# ANGLE/STRAIGHT END COCK UPGRADE INSTRUCTIONS

**PURPOSE** To upgrade any style Cock manufactured before Nov. 2000 to include the Angle Cock Handle Assembly Torque Kit, P/N 33890-1 (Left Hand), P/N 33890-2 (Right Hand) or Straight End Cock Handle Assembly Torque Kit, P/N 34270-1 (Left Hand) or P/N 34270-2 (Right Hand). This upgrade should be considered when the Cock does not meet the inspection criteria of Maintenance Advisory MA-65 and ELLCON-NATIONAL Form 107.

E-N MODEL 7270-RH  
ANGLE COCK SHOWN

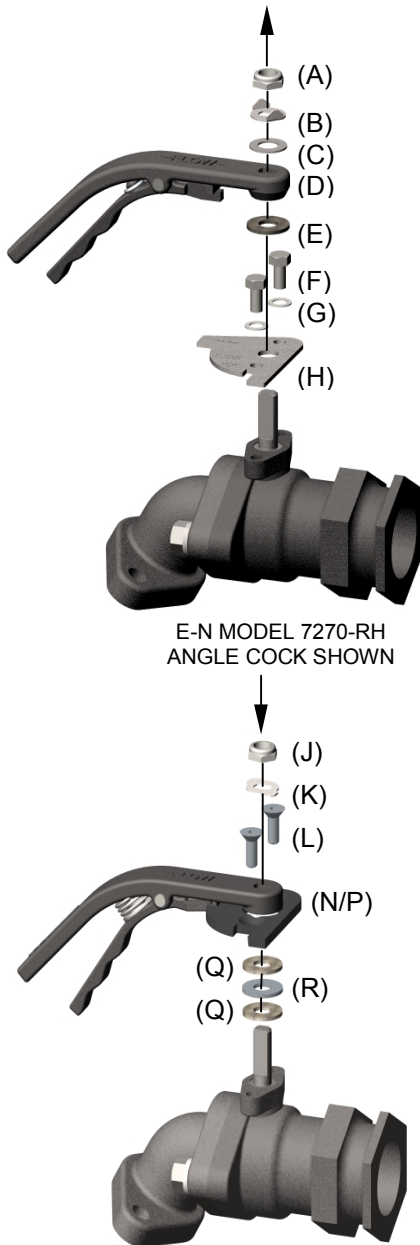
1. If present, bend Retainer (B) tabs away from Lock Nut (A) so that the Nut flats are exposed using a drift pin and ball peen hammer.
2. Using a 3/4" wrench or socket, remove Lock Nut (A).
3. If present, remove Retainer (B).
4. If present, remove Belleville Spring (C).
5. Lightly pry between the underside of Handle and top of stainless steel Stop Plate (H) to remove Handle Assembly (D).
6. If present, remove Friction Disc (E).
7. Remove 5/16" Hex Screws (F) and Lock Washers (G).
8. Remove stainless steel Stop Plate (H).
9. Discard all of these parts.

1. Install a Friction Disc, Poly Spring, and Friction Disc (Q,R,Q) and seat them directly on Cock Body.
2. Install the Locking Lever Tang of the Handle Assembly into the open position Lock Notch of the Stop Plate.

3. Seat handle assembly on stop plate (N,P), install handle assembly with stop plate over stem and seat on angle cock body.
4. It is recommended that Loctite Thread Locker 242 or equal be applied to threads and install two 5/16"-18 Socket Flat Head Screws (L) in threaded holes and tighten to 10 foot pounds torque.

5. Place a new Retainer (K) over Stem and seat it directly against Handle.
6. Install a new 1/2" Lock Nut (J) on Stem and tighten to 20 foot-lbs. torque.

7. Operate Handle Assembly (closed and open) twice to seat Friction Disc.
8. Repeat tightening of Lock Nut to 20 foot-lbs. torque. This should result in 75-100 inch-lbs operating torque.

9. Operate Handle Assembly and check that Locking Tang on Locking Lever latches into Lock Notch in both open and closed positions.
10. Bend two tabs on Retainer (K) up and fully against flats of 1/2" Lock Nut using a drift pin and ball peen hammer.
